# DOCUMENT CHANGE NOTICE (DCN)

DOCUMENT No. (DOC-REV-GP. ID)	TITLE	NEW REV.
D960012-C-D	Sensor/Actuator Head	D
D960754-B-D	Sensor/Actuator Head	C

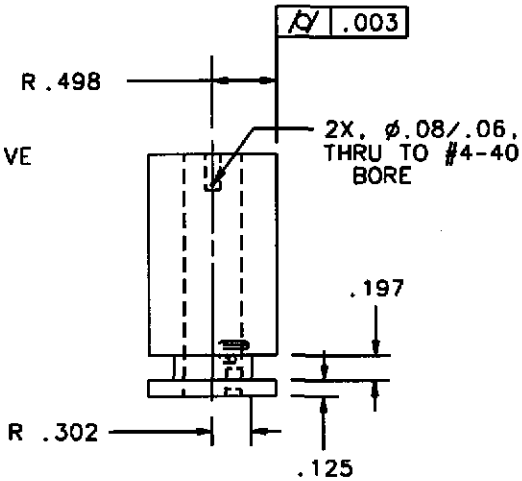
Note 5 FROM: MASK THE TWO #4-40 THREADED HOLES AND COAT ENTIRE HEAD WITH A THIN LAYER OF TITANIUM OR MOLYBDENUM TO PROVIDE UNIFORM RESISTIVITY OF .25 OHMS/SQUARE TO 25 OHMS/SQUARE.

TO: MASK THE TWO #4-40 THREADED HOLES AND COAT ENTIRE HEAD WITH A THIN LAYER OF CONDUCTIVE MATERIAL TO PROVIDE UNIFORM RESISTIVITY OF .25 OHMS/SQUARE TO 25 OHMS/SQUARE.

**REASON FOR CHANGE:** Titanium and molybdenum are not the only conductive materials that will work in this application. Zirconium nitride may also be used.

1. FILLETS: R .015 MAX
2. BREAK ALL SHARP EDGES  
.02/.01 X 45°
3. MATERIAL: CORNING MACOR
4. T ± T DRAFT ALLOWED  
FOR SLOT. SLOT DIMENSIONS  
VALID AT DATUM -A-
5. MASK THE TWO #4-40 THREADED  
HOLES AND COAT ENTIRE HEAD  
WITH A THIN LAYER OF CONDUCTIVE  
MATERIAL TO PROVIDE UNIFORM  
RESISTIVITY OF .25 OHMS/SQUARE  
TO 25 OHMS/SQUARE.
6. GLUE SPACER INTO HEAD WITH  
PERKIN ELMER VAC-SEAL EPOXY.  
TOP OF SPACER TO BE FLUSH  
WITH DATUM -A-
7. COAT HEAD BEFORE INSTALLING  
THE SPACER.
8. MASK SLOT AND OPTIONAL  
ø.438, BEFORE COATING.  
MASK SURFACE DEFINED BY  
DATUM -B- BEFORE COATING.
